ET 13-0024

Subject: Docket No. 50-482: Response to Request for Additional Information Regarding License Amendment Request to Revise Technical Specification (TS) 3.8.1, "AC Sources - Operating" Surveillance Requirement 3.8.1.10

Response to Request for Additional Information

Figure 4
 Single-Load Rejection Test (followed by ESW pump start)
 (Page 1 of 1)

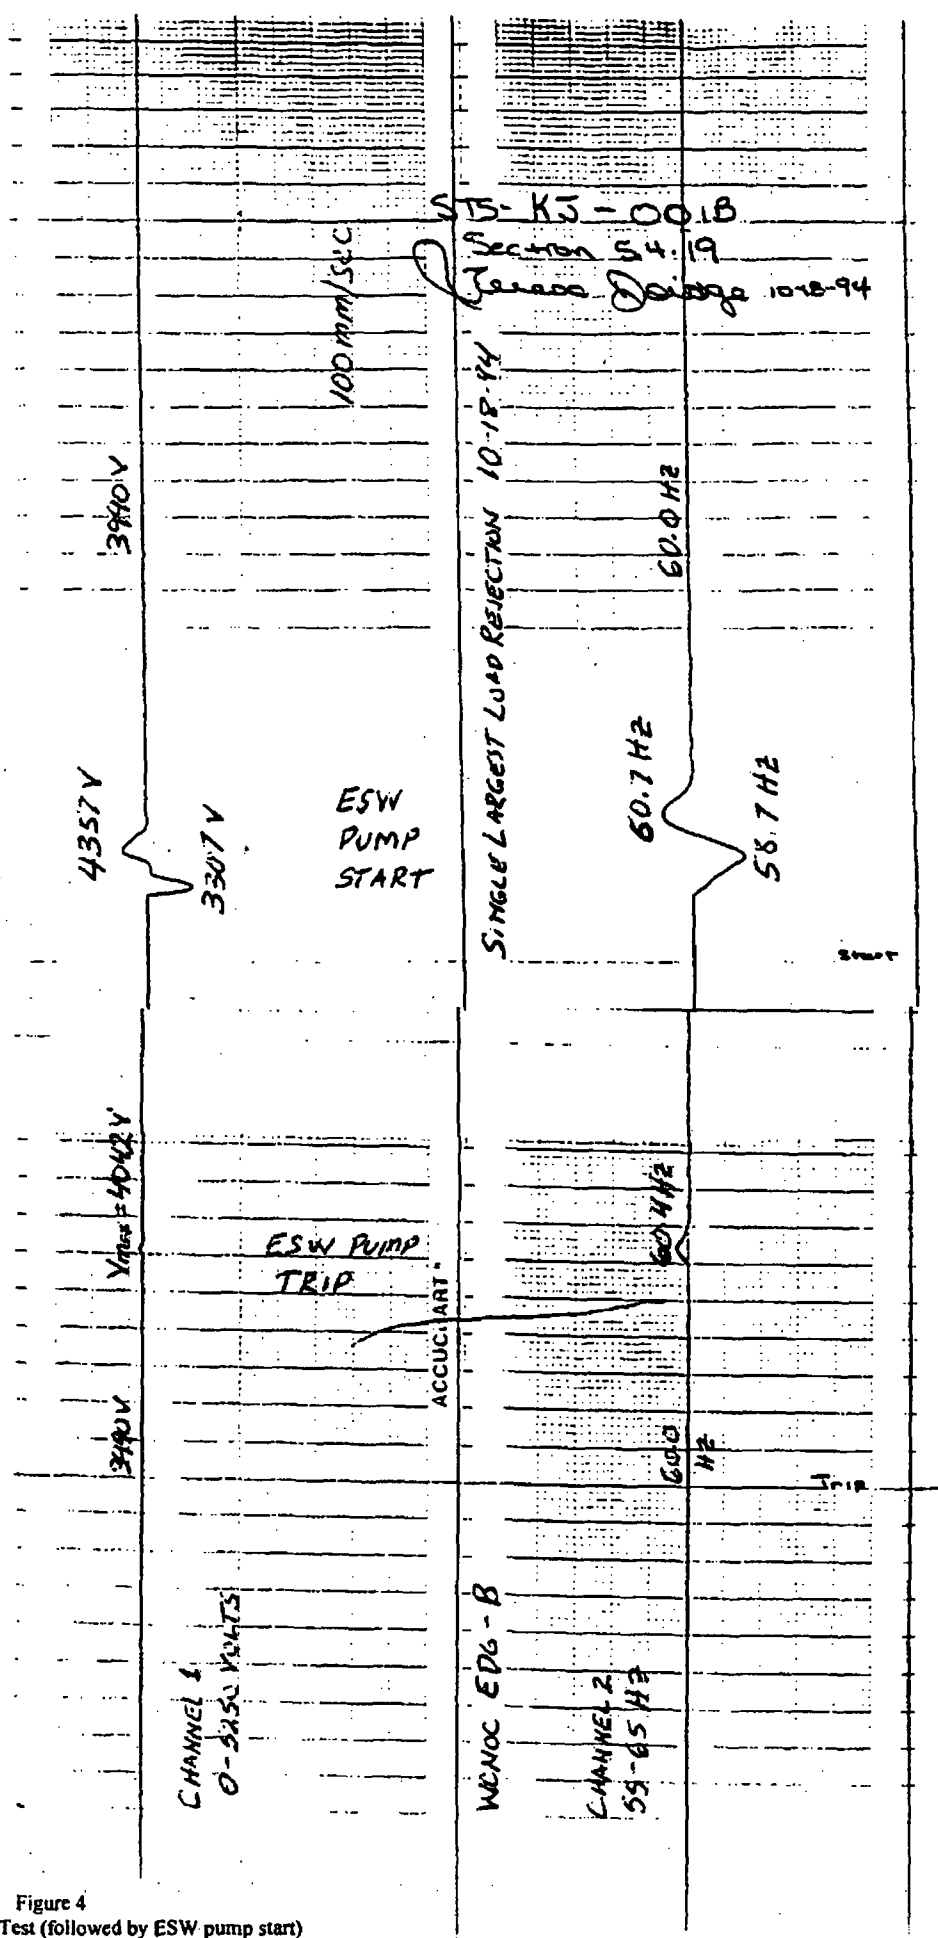
In the event that the DGs are supplying the safety-related buses and a large load rejection event occurs, please discuss how the operating equipment on the safety-related buses will not be degraded if the DG output voltage spikes to 4992 V.

Response: The essential service water (ESW) pump motors are 1750 Hp and are the single largest load associated with the DG. License Amendment No. 101 (Reference 3) approved the deletion of the single-load rejection surveillance test. During the review of the license amendment request, WCNOG responded to a request for additional information (Reference 4) and provided information associated with the voltage swing during the single-load rejection test. From Reference 4, WCNOG concluded that the voltage and frequency swings for the single-load rejection test stay within steady state values during the transient. The Enclosure provides Figure 4 (from Reference 4) that shows a recording of voltage and frequency during a single-load rejection test (pump trip followed by a pump start). The NRC safety evaluation (Reference 3) concluded, in part:

“Operation within the steady state criteria provides assurance of adequate voltages and frequencies for the continuous operation of the connected loads and specifically for induction motors.”

The single-load rejection test has not been performed since implementation of License Amendment No. 101. However, in 2011, WCNOG performed a partial load rejection test on the 'A' DG from a grid load of 3450 kW. The initial bus voltage was 4095 V and the peak was 4384 V. The partial load rejection test was completed satisfactorily with no degradation to operating equipment.
